L-PI-09-007  
10 CFR 54

Prairie Island Nuclear Generating Plant Units 1 and 2  
Dockets 50-282 and 50-306  
License Nos. DPR-42 and DPR-60

Responses to NRC Requests for Additional Information Dated December 24, 2008  
Regarding Application for Renewed Operating Licenses

**Figure 1f-1**  
**SBO Event Tree Addressing RCP Seal Leakage for Unqualified Seal Material**

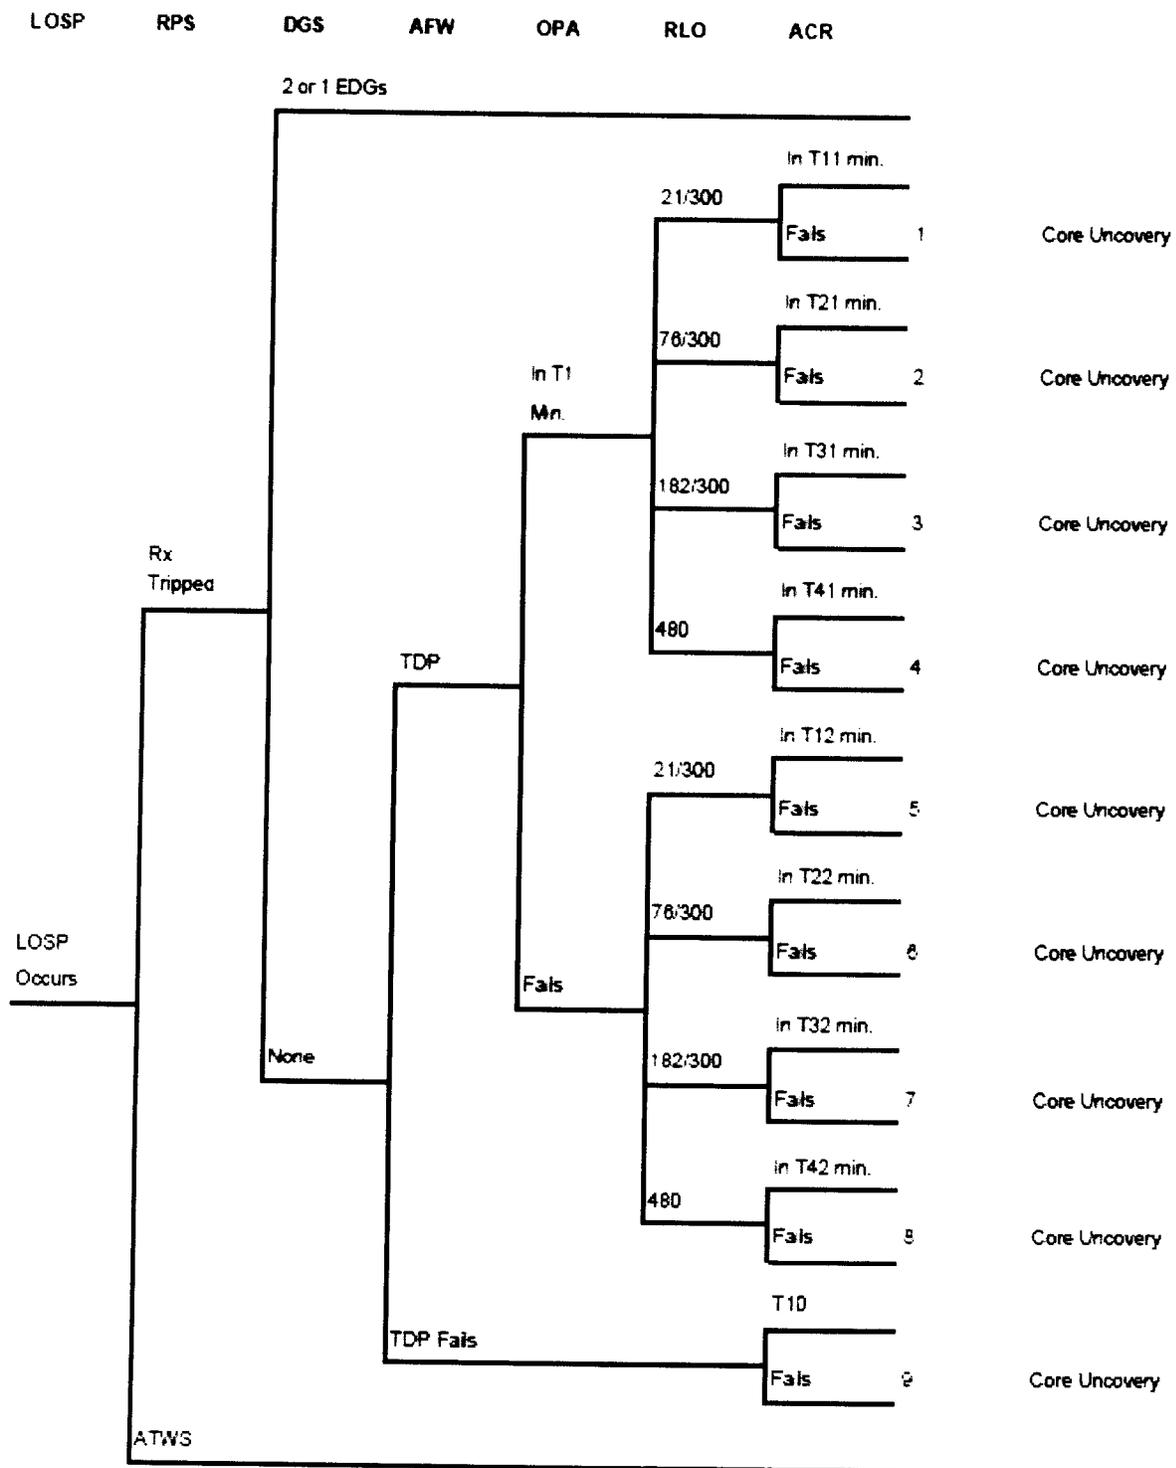
The Prairie Island Nuclear Generating Plant (PINGP) PRA uses a Westinghouse reactor coolant pump seal loss-of-coolant accident (LOCA) model (WCAP-10541, 1986), that pre-dates the Westinghouse Owners Group (WOG) 2000 model approved by the NRC in 2003 for plants using high-temperature O-rings. The peer review of the PINGP PRA occurred prior to the approval of the WOG 2000 model, and as such would not have

identified this as an issue. Provide an assessment of the impact on the severe accident mitigation alternative (SAMA) identification and screening if the PINGP PRA utilized the WOG 2000 model.

Figure 1f-1 below is a reproduction of Figure 5-1 from WCAP-16141:

Since the IPE, the PINGP seal LOCA model has relied on the results of thermal hydraulic analysis cases run using MAAP code 3.0b. This version of the MAAP code is known to be significantly conservative with respect to the timing of core uncover and core damage following initiation of RCP seal LOCA events. PINGP is currently in the process of updating its MAAP thermal hydraulic analyses to new cases run using Revision 4.0.6 of the MAAP4 computer code. Currently only a limited set of SBO cases have been run and the available case results are considered preliminary. Therefore, a set of generic thermal hydraulic analysis cases using MAAP4 was used as a check of the preliminary, plant-specific results. WCAP-16141, Appendix A provides generic core uncover times for Westinghouse reactor classes, including 2-loop plants such as Prairie Island. The document states:

Based on these results, a SBO event tree model for PINGP based on the Rhodes model presented in WCAP-16141, Section 5.0, was developed, except that only those event tree branches corresponding to the largest seal leakage assumption (480 gpm/pump) were included, as there are no available plant-specific or generic MAAP cases that model the Rhodes assumption of a 300 gpm leak occurring at 2 hours. This treatment provides a very conservative, bounding model for SBO; however, the results are
